ORDINANCE NO. 16-9-2

CHANGE ORDER

Project: Willowridge Drainage Pump Station

OWNER's Contract No. P080905-4A

ST. CHARLES PARISH, LOUISIANA
 WILLOWIDGE AREA
 WATERLINE CONNECTION

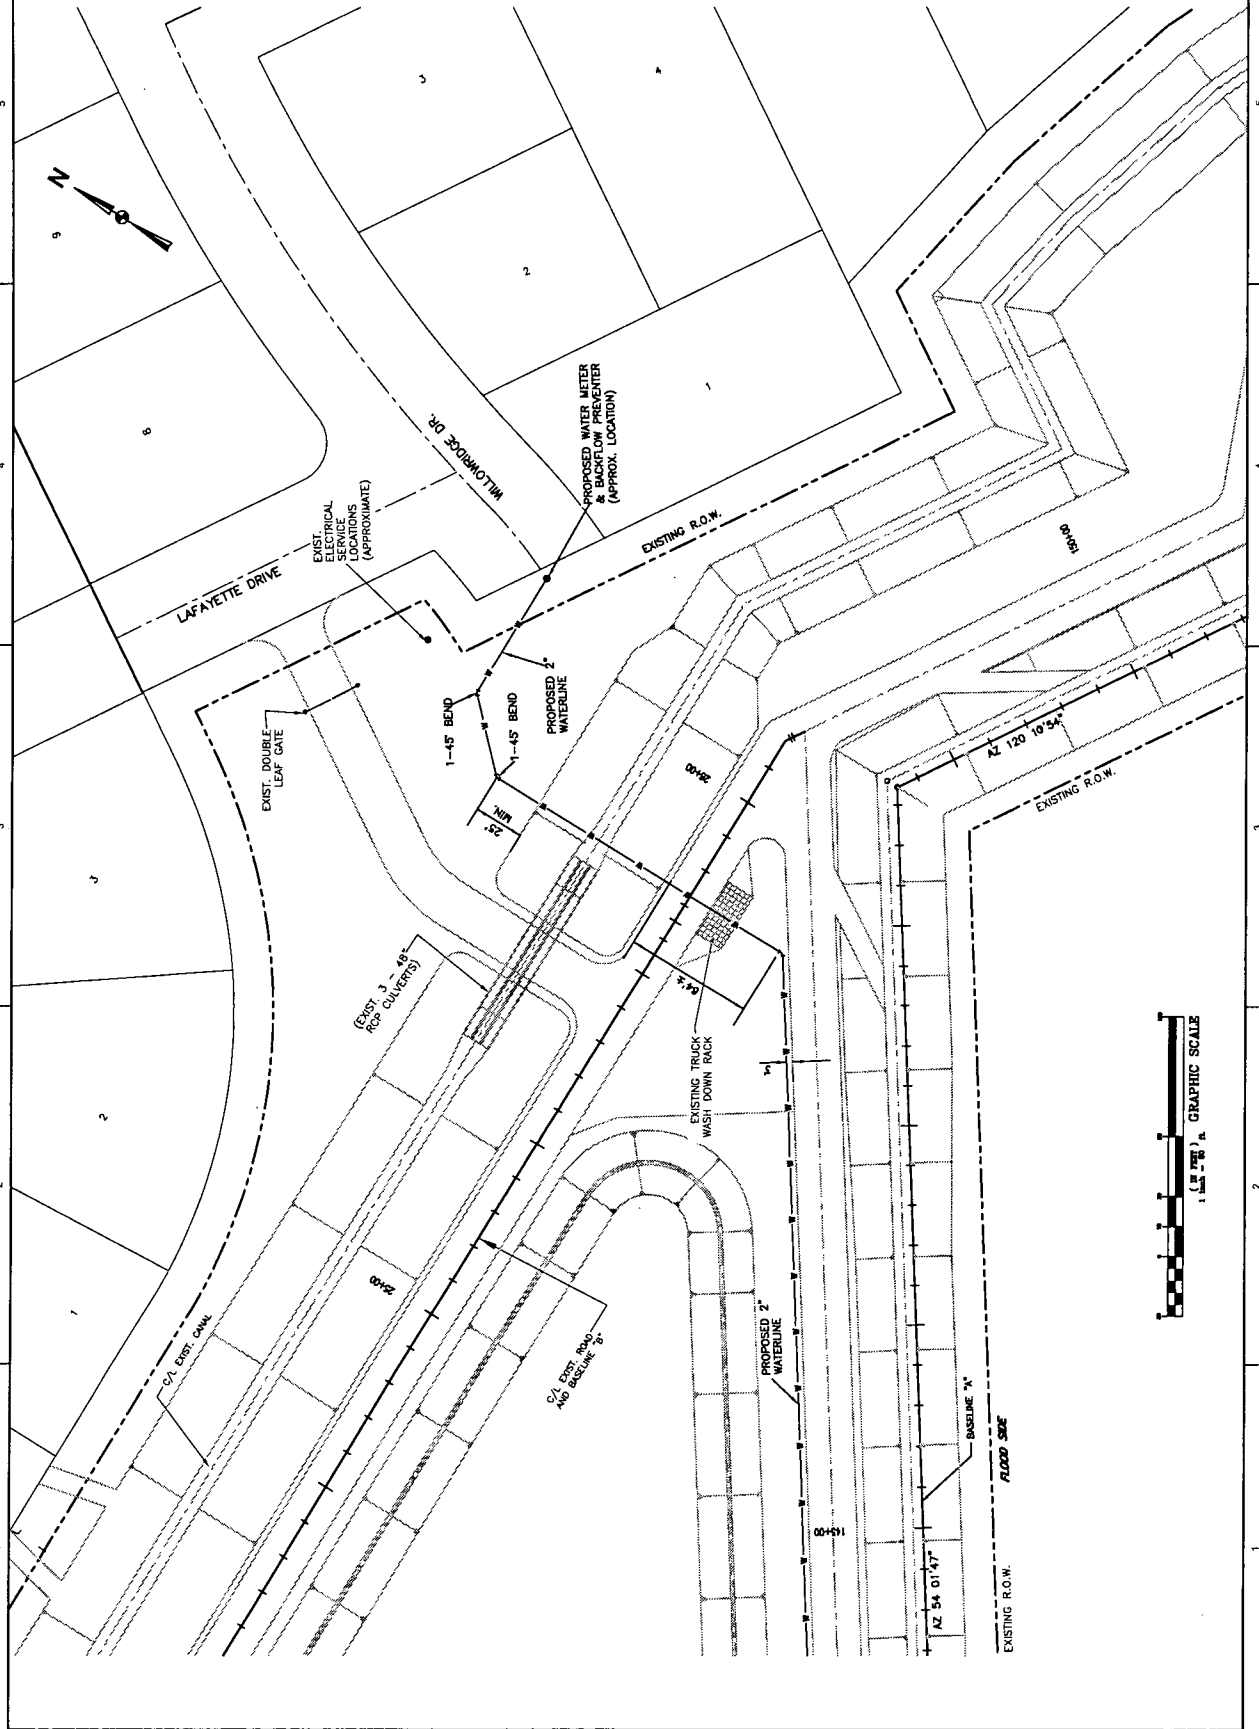
1. Delete the Following Work Items:
 - a. N/A
2. Add the Following Work Items:
 - a. New Contract Item 59: Work Change Directive #1
Installation of a 2" Water Meter – Contractor is to tap existing main and install water meter at the location shown on "Sht. 1 Waterline Connection"
Addition of \$ 4156.00 (L.S.).

Description: In response to RFI 5 Contractor shall install an Owner approved 2" water meter near the intersection of Lafayette Dr. Willowridge Drive and a 2" Backflow Preventer (as submitted in submittal #12) immediately downstream of the water meter. Piping shall be run from the backflow preventer to the waterline shown on Sht. C2.0.
